DEVELOPMENT REVIEW BOARD  
SUPPLEMENTAL SUBMITTAL

PROJECT NO. PR-2019-002277  
Application No. SI-2019-00246

SUBMITTAL DESCRIPTION: DRB Site Plan Resubmittal.

RE: Adagio Apartments  
PR-2019-002277

A-303A

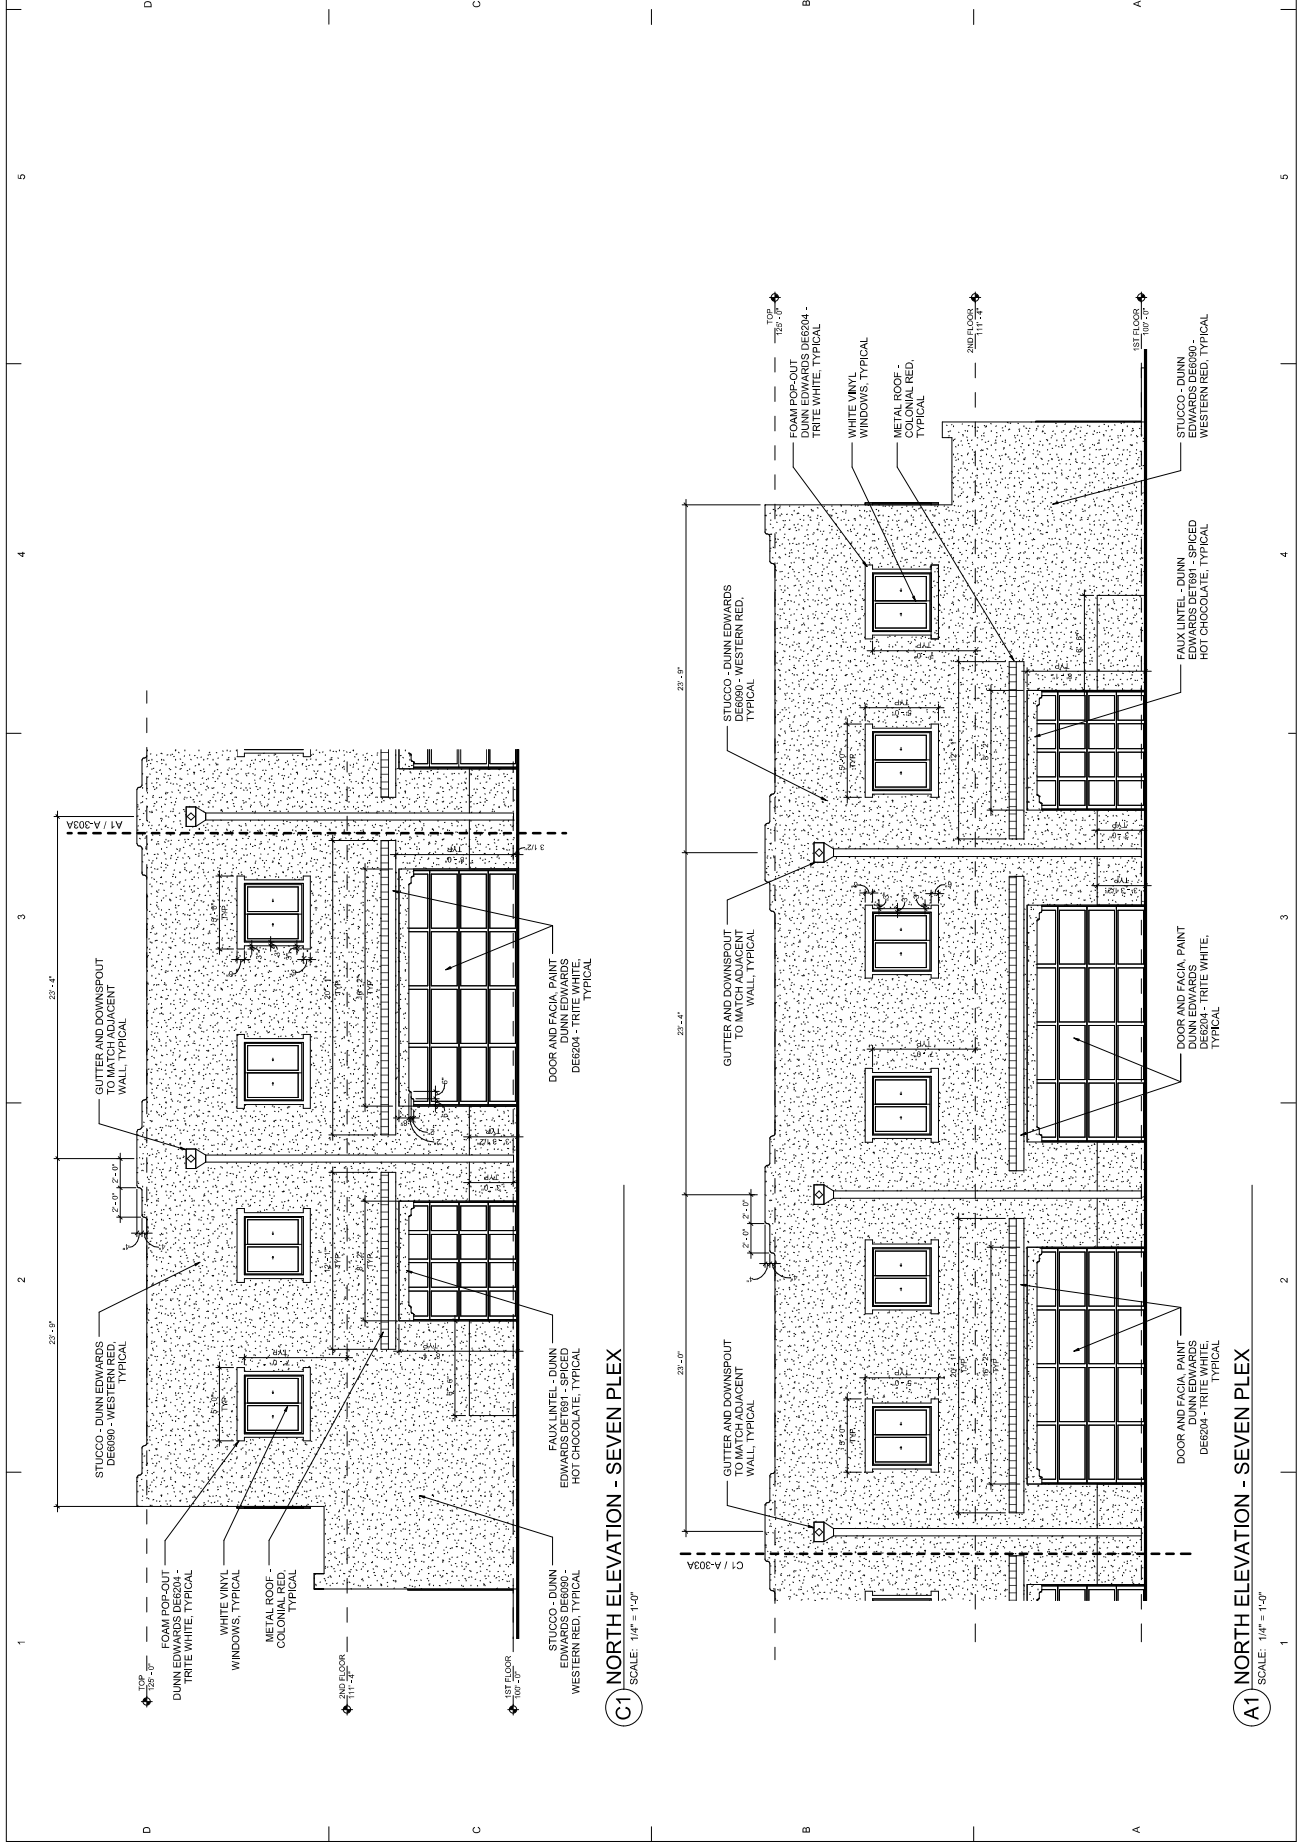
- / The townhomes shall have a color palette consistent with the depiction on the color elevations included in the October 20 supplemental submittal from the applicant.
  - o *Response: I believe this comment was addressed with our last submittal. Regardless, the latest elevations are included with this submittal.*
